IE Bulletin No. 78-05

**MALFUNCTIONING OF CIRCUIT BREAKER AUXILIARY CONTACT MECHANISM -
GENERAL ELECTRIC MODEL CR105X**

105X AUXILIARY CONTACT (CHANGEOUT OF PLUNGER ARM AND INSULATION)

FIGURE 1
REMOVING OVERLOAD RELAY MOUNTING BRACKET

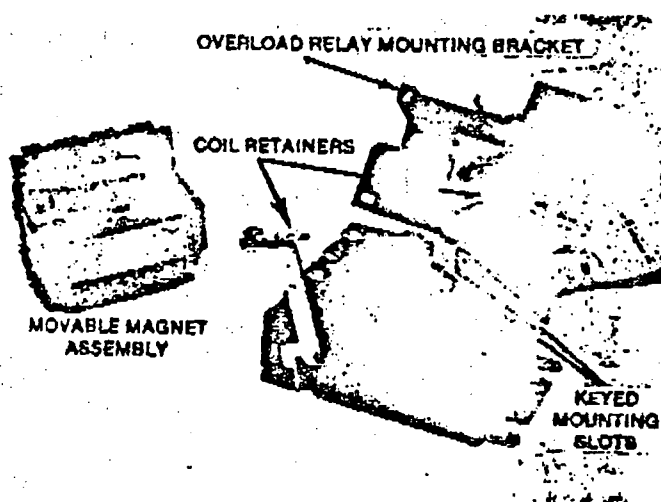
REMOVING OVERLOAD RELAY BRACKET (SEE FIG. 1)

1. Remove all electrical power from device.
2. Disassemble device by pressing on the coil while pulling out on the coil retainers. Move retainers back and away from coil.
3. Grasp movable portion of magnet and pull out, removing magnet assembly, coil, molded cover and movable arm in one motion. (NOTE: On reversers or multispeed starters, this magnet assembly is linked to the mechanical interlock arm between contactors and should be tipped toward interlock arm to facilitate easy removal.)
4. Remove overload relay bracket by sliding it out of the keyed slots in the molded base. (NOTE: If any wires are too short to allow easy removal, temporarily disconnect these.)
5. Remove overload relay from bracket by loosening screw on bottom of overload bracket.

FIGURE 2

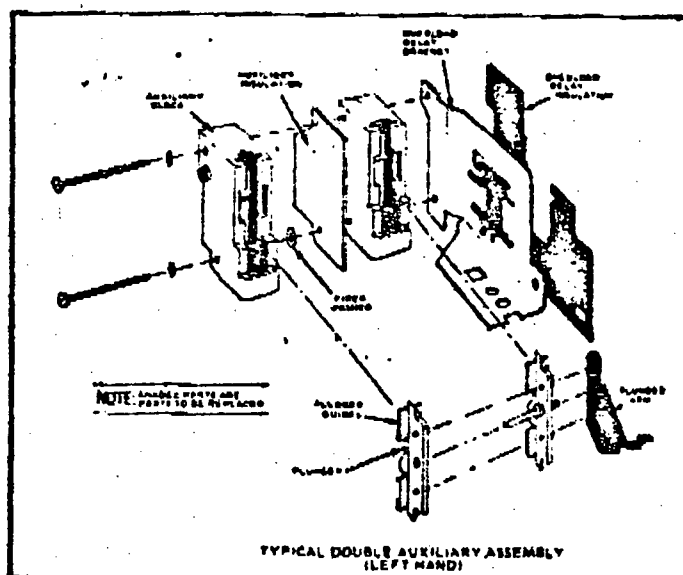
CHANGING PLUNGER ARM & INSULATION (SEE FIG. 2)

1. Slide plunger assembly out of auxiliary contact block, by lifting up and out.
2. Select the new plunger arm that is bent the same way as the one installed.

3. Loosen screw on plunger to release metal arm but DO NOT REMOVE SCREW FROM PHENOLIC PLUNGER (OR PLUNGERS).
4. Mount new plunger arm on plunger. Fasten arm to plunger with screw (or plunger post if installing double aux. blocks).

5. Apply thin coat of aeroshell grease along plunger guides.
6. Reinstall plunger assembly in contact block.
7. Reassemble overload to mounting bracket. Remove overload insulation and install new. (NOTE: Overload insulation must be removed and replaced with new insulation supplied with kit.)

8. Remount complete assembly on contactor base.
9. Reconnect any wires previously removed.
10. Reassemble magnet assembly to contact base (on reversers or multispeeds be sure to interlock this assembly with mechanical interlock arm. Check for free movement of armature assemblies and mechanical interlocks).

11. Observe that auxiliary contact plunger assemblies are operating properly.
